# ORIGINATION FORM

Proposed Revisions to a Standard Plans Index  
(Please provide all information – Incomplete forms will be returned)

Index Number: 450-078  
Sheet Number (s): 1  
Index Title: Florida-I 78 Beam - Standard Details

Deleted Intermediate Diaphragm Inserts

ELEVATION AT END OF BEAM (Flanges Not Shown For Clarity) (End 1 Shown, End 2 Similar)

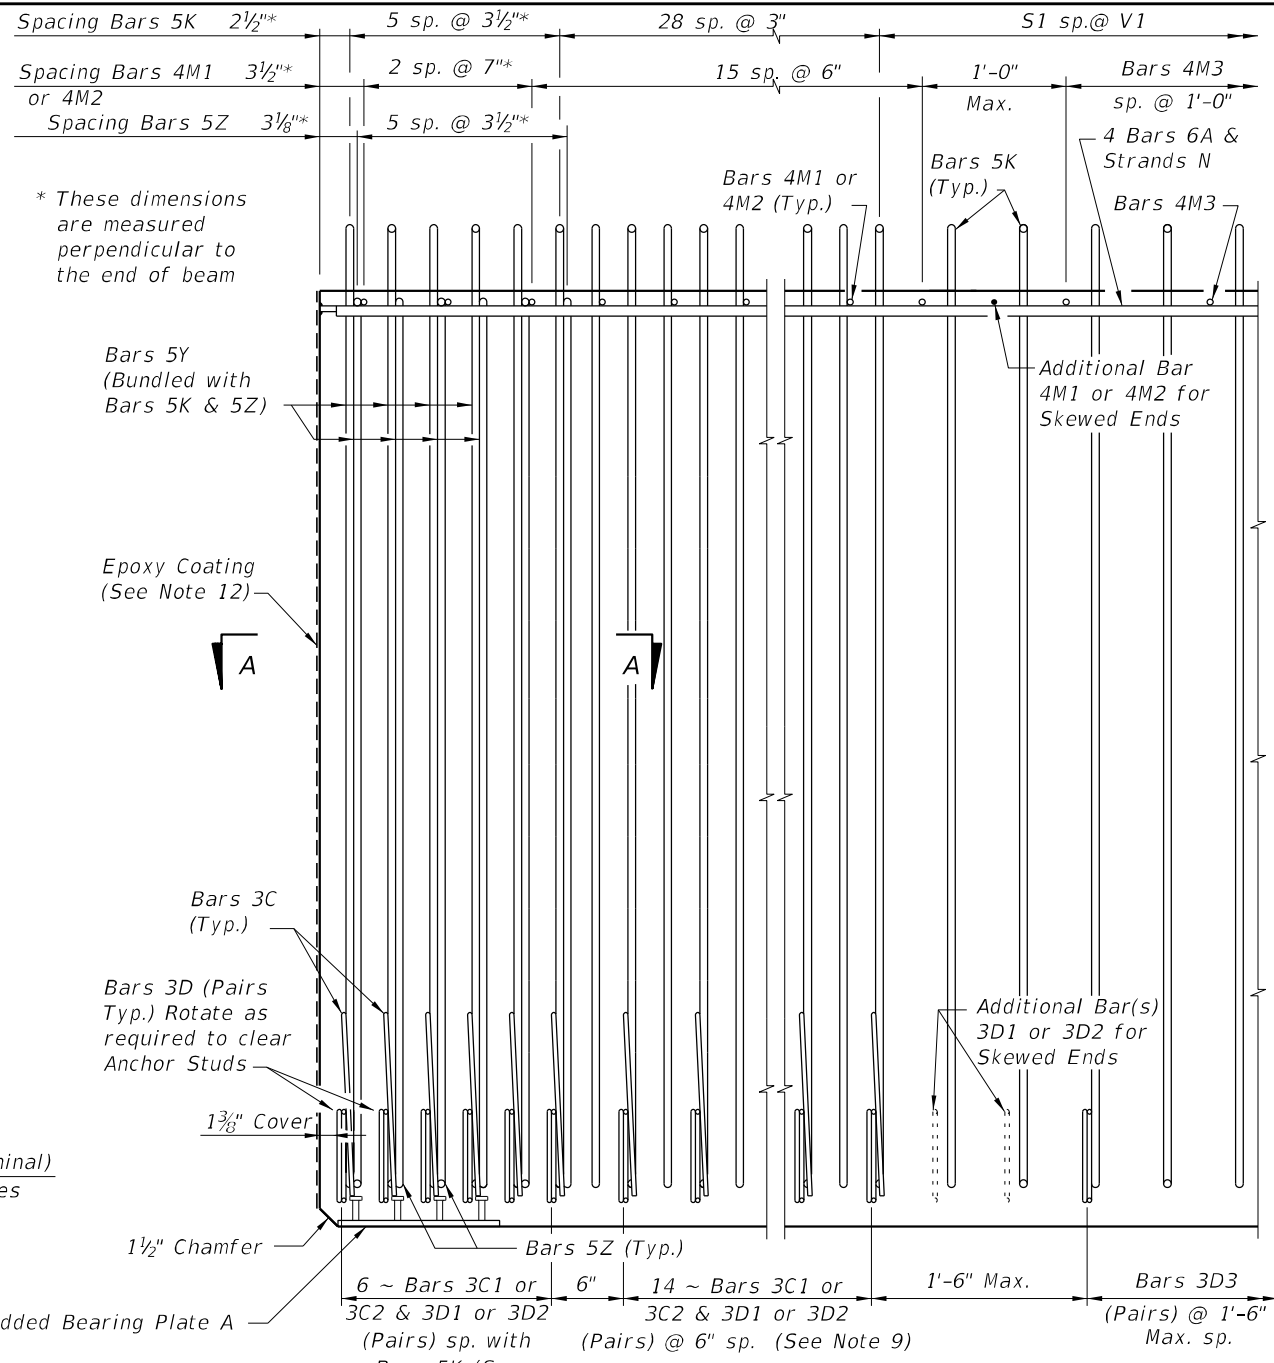
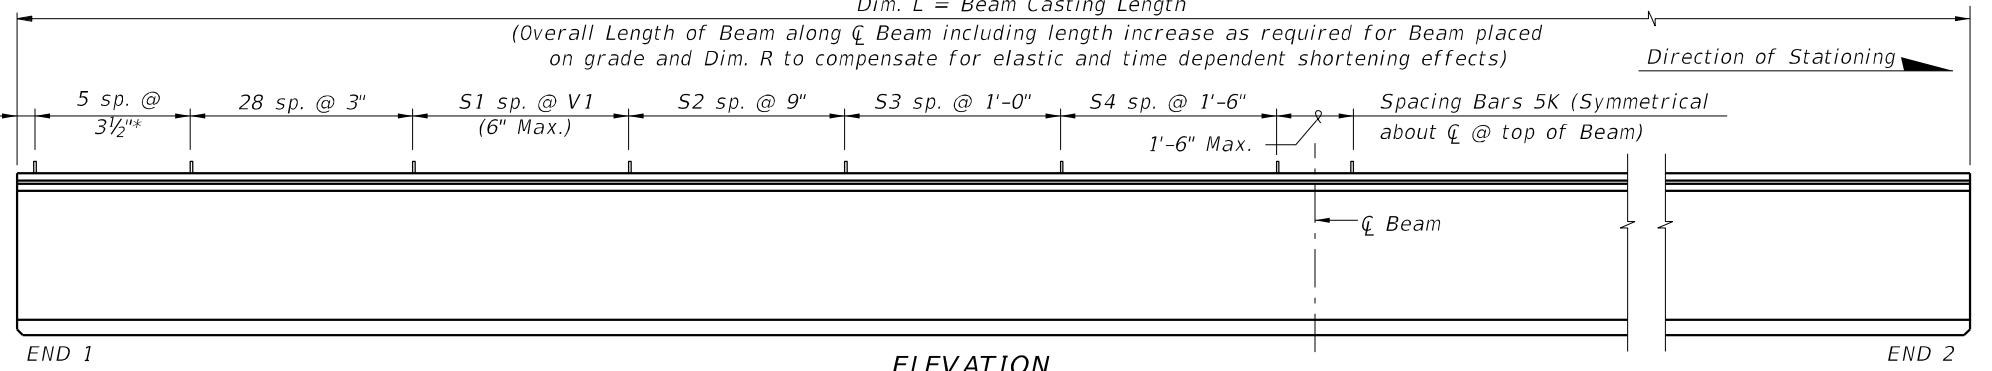
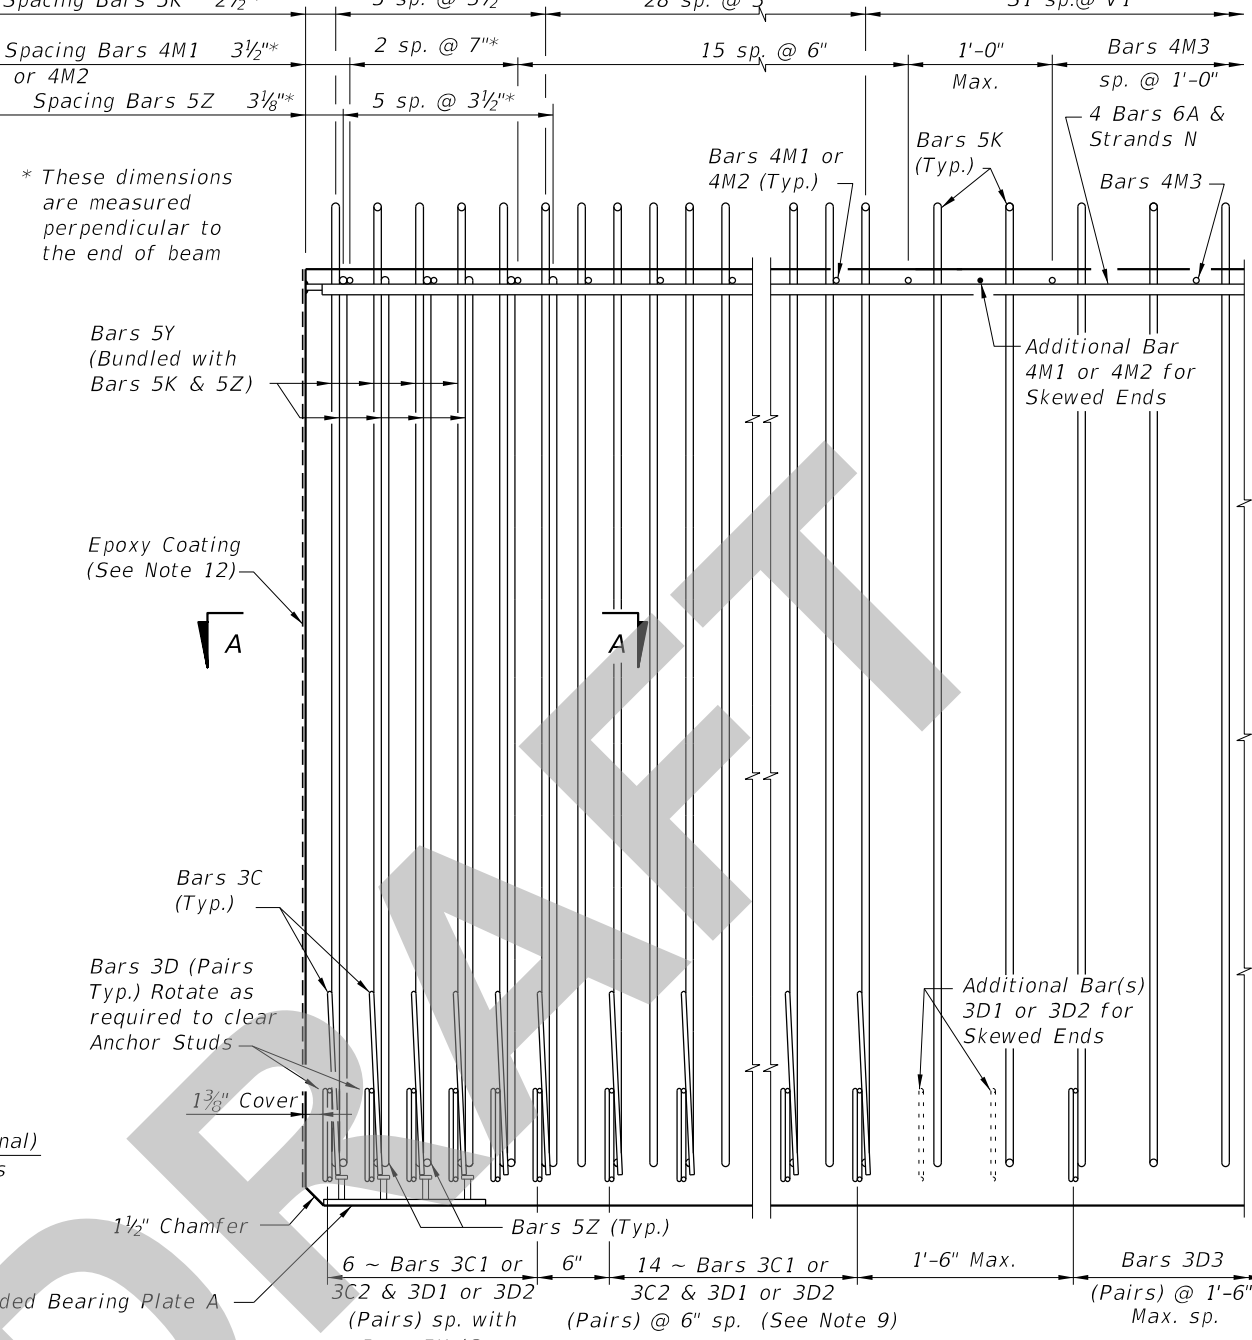
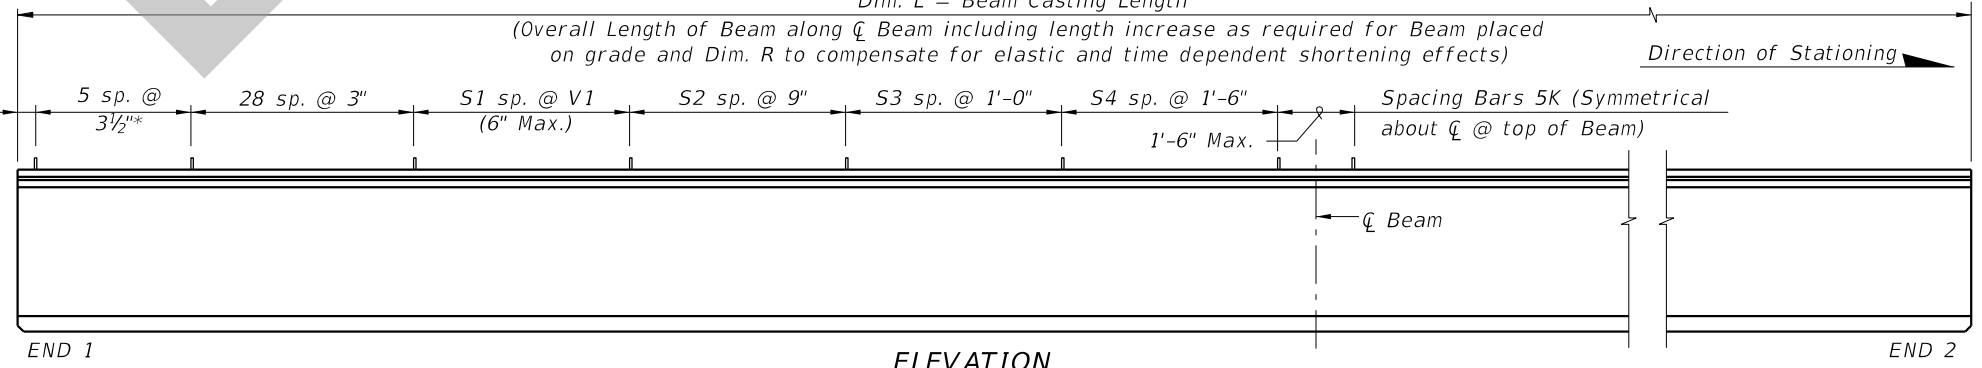
Diaphragms not required; therefore Inserts not required.
